City of Dublin Planning and Zoning Commission

Planning Report

BSD Scioto River Neighborhood District – Bridge Park Mixed-Use Development – Preliminary Plat

Agenda Item	4
Case Number	15-002PP
Site Location	East of Riverside Drive, north of West Dublin-Granville Road, west of Dale Drive, south of John Shields Parkway.
Proposal	This is a request for a preliminary plat for a new mixed-use development on a 30.9-acre site. The proposal includes new public streets and nine blocks for development for the overall site.
Applicant	Nelson Yoder, Crawford Hoying Development Partners.
Planning Contact	Rachel S. Ray, AICP, Planner II (614) 410-4656, rray@dublin.oh.us
Requests	Review and recommendation of approval to City Council of a preliminary plat under the provisions of the Subdivision Regulations (Chapter 152 of the Dublin Code of Ordinances).
Planning Recommendation	Recommendation of approval of the preliminary plat with two conditions. Based on Planning's analysis, the proposal meets the requirements of the Subdivision Regulations, subject to two conditions.

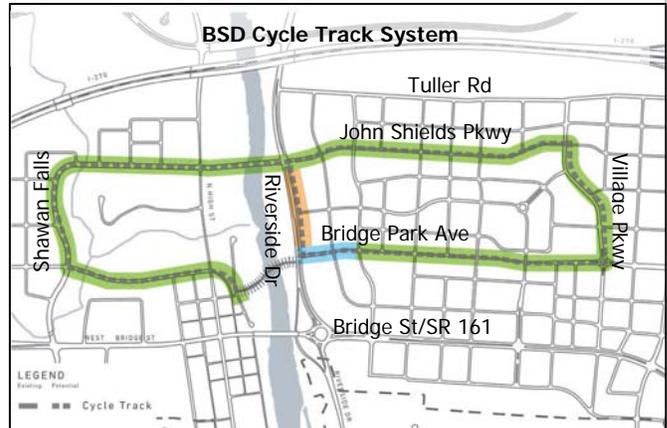
The Subdivision Regulations §152.029(B)(6) require rights-of-way at street intersections be connected with a straight line tangent to the intersection. The plat does not include this chamfered intersection detail due to the Bridge Street provisions of the Zoning Code that require corner occupancy by buildings (refer to the example diagram on the previous page). The Commission and City Council may modify this requirement with the approval of the plat. Engineering recommends approval of this modification.
